***RESPONSE ACTION MEMORANDUM***

**Generator Fuel Spill Site (SS014)  
Maui Space Surveillance Complex,  
Haleakalā, Hawai‘i**

**Subject:** **1) Backcheck of Response to Comments (RTCs) for the *Draft Response Action Memorandum*; and 2) Review of the revised *Draft Response Action Memorandum, Generator Fuel Spill Site (SS014), Maui Space Surveillance Complex, Haleakala, Hawaii, dated July 2024***

Subject: **Review of Draft Response Action Memorandum, Generator Fuel Spill Site (SS014), Maui Space Surveillance Complex, Haleakala, Hawaii; dated April 2024**

**Figure 2**  
**Soil Boring Results**  
**Maui Space Surveillance Complex**  
**Haleakalā, Maui**

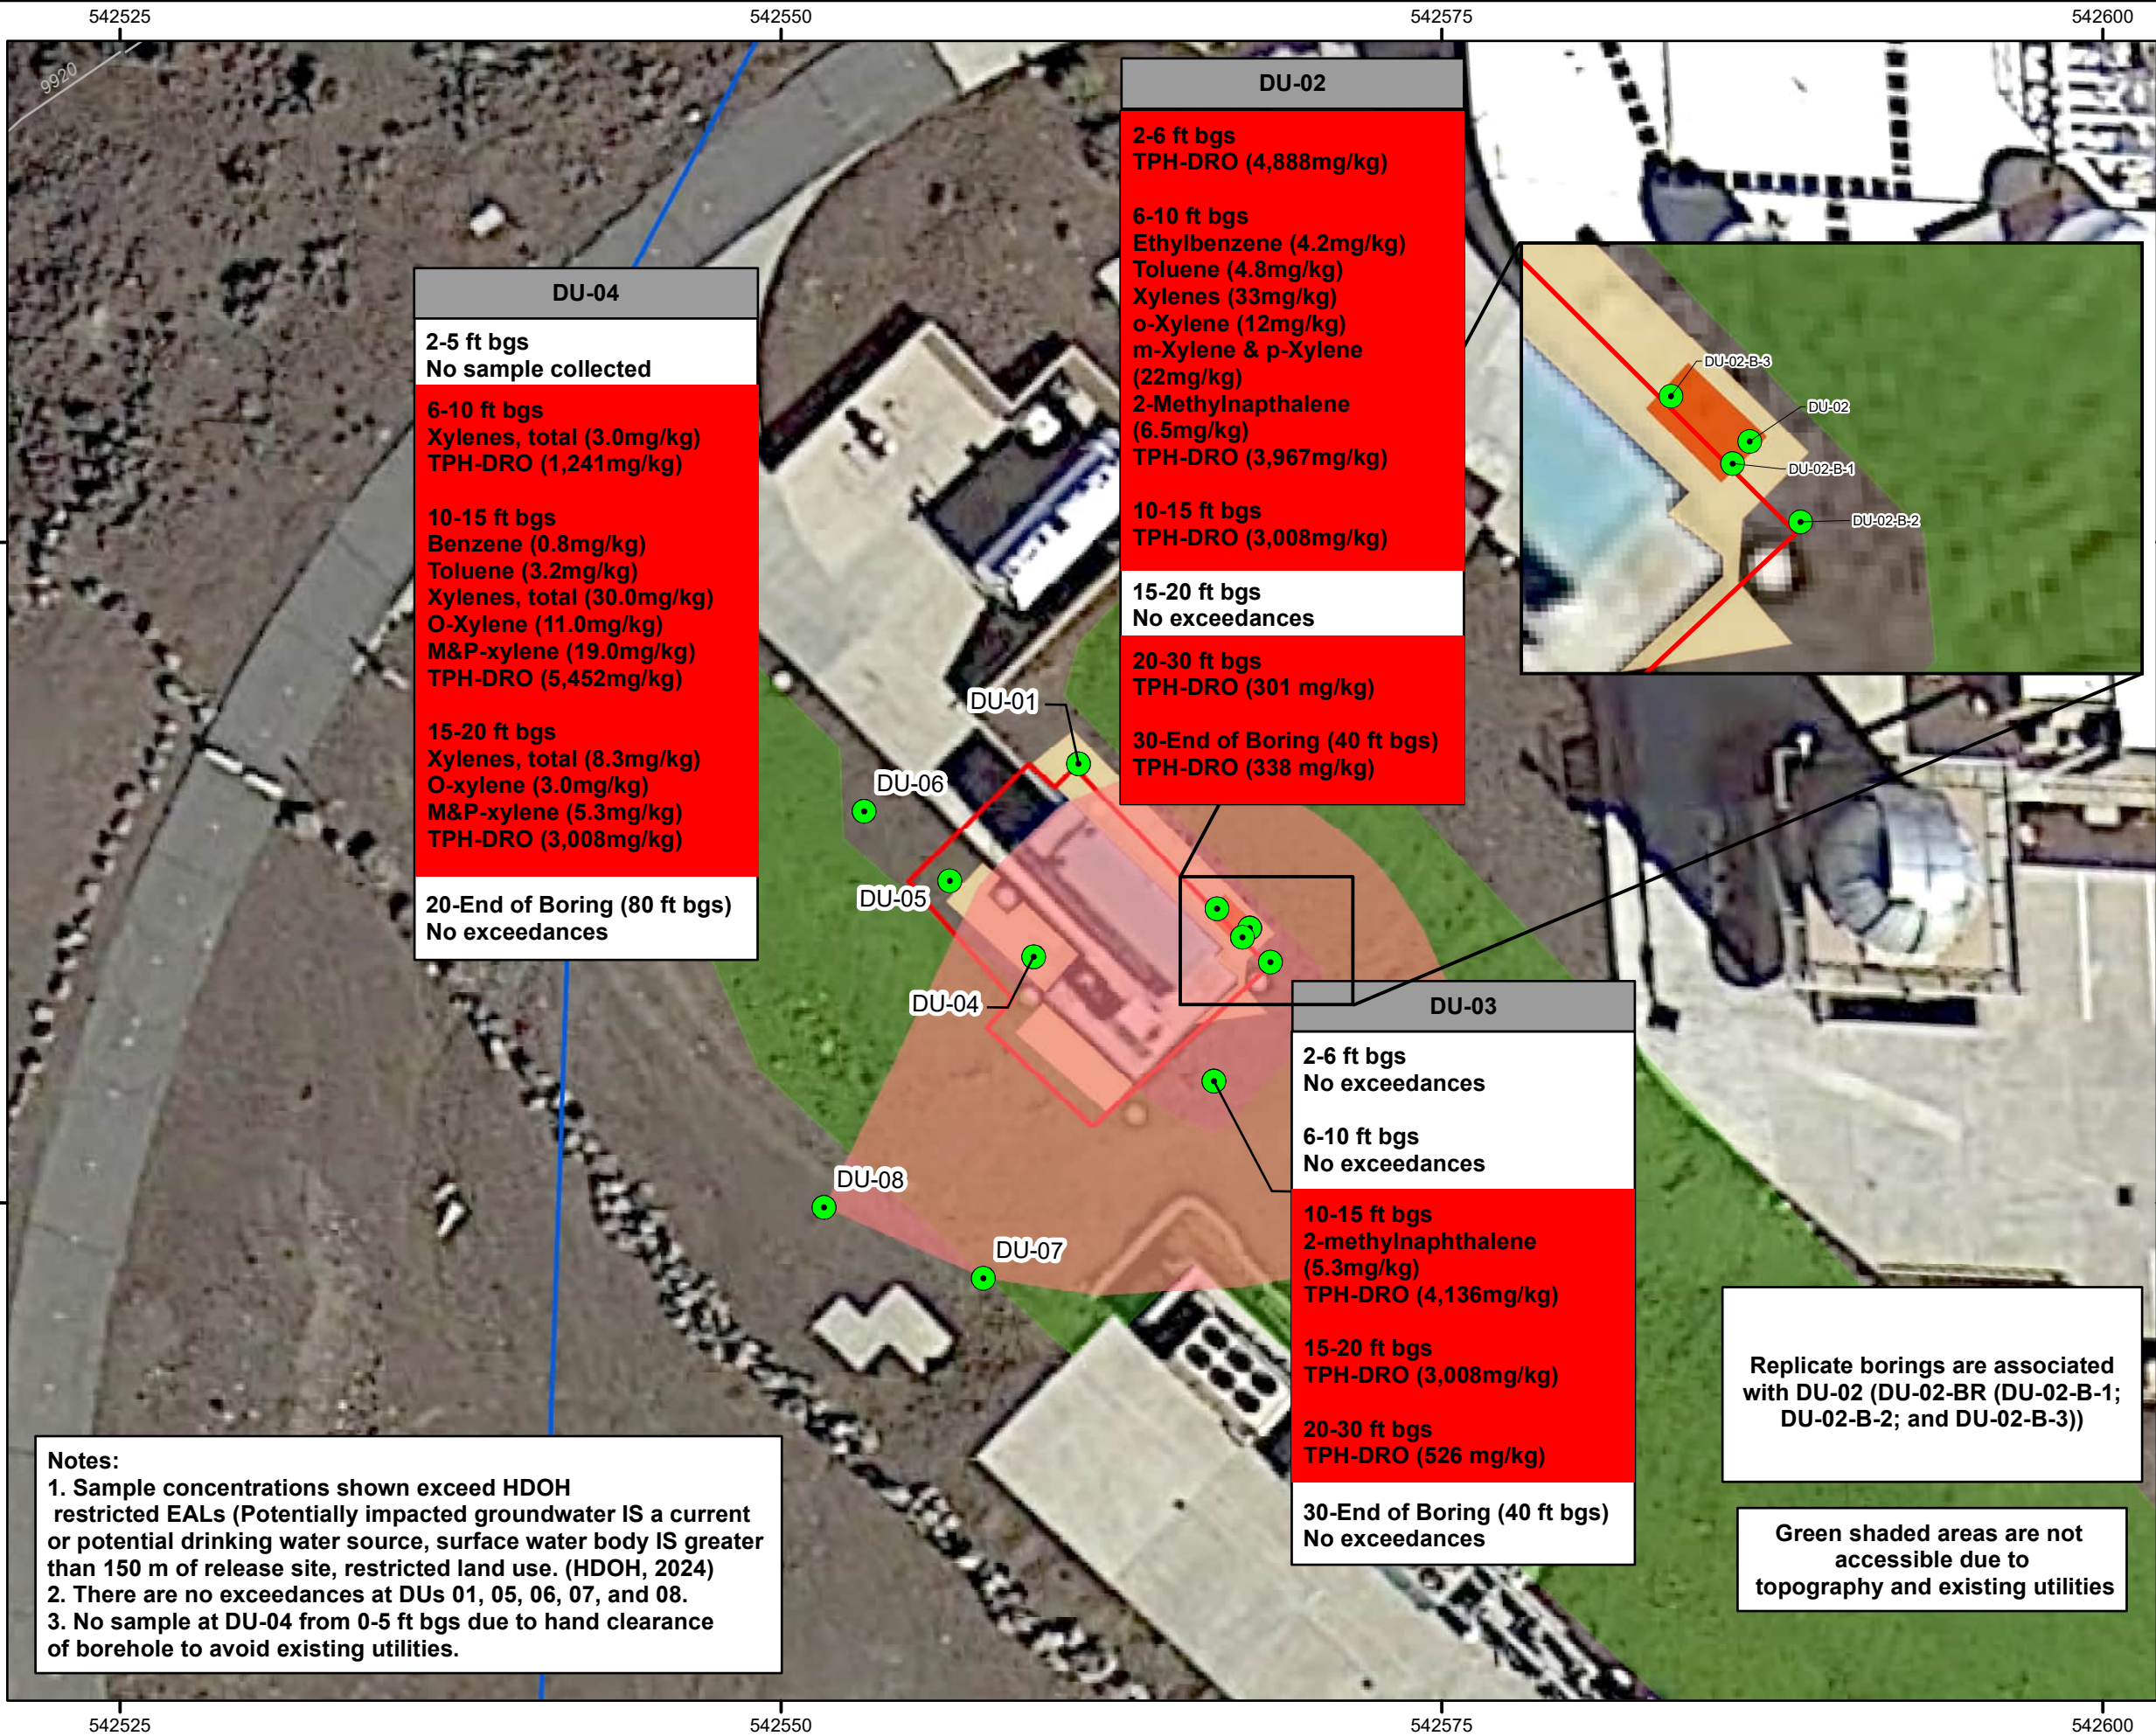
HDOH 17 June 2024 Comment: HDOH has updated the Environmental Action Levels (EALs). Please refer to and use the updated Spring 2024 EALs in this report, which can be found at <https://health.hawaii.gov/heer/guidance/ehe-and-eals/>. Please apply these EALs to the report globally (e.g., Table 2, Table 3, applicable in-text references, Section 6.0).

- Section 1.6, 2<sup>nd</sup> sentence, Page 4: Please revise the estimated depths and volume of subsurface soil exceeding the site-specific EALs, as a larger volume of soil now exceeds the site-specific EALs.
- Section 3.3.1, Page 13: Please revise the estimated depths and volume of subsurface soil exceeding the site-specific EALs, as a larger volume of soil now exceeds the site-specific EALs.
- Section 4.2.5 and Table 7, Page 23: If necessary, please revise the estimated cost for Alternative 3, as all supersack soil is above the unrestricted EALs and additional in-situ soil is above the site-specific EALs.
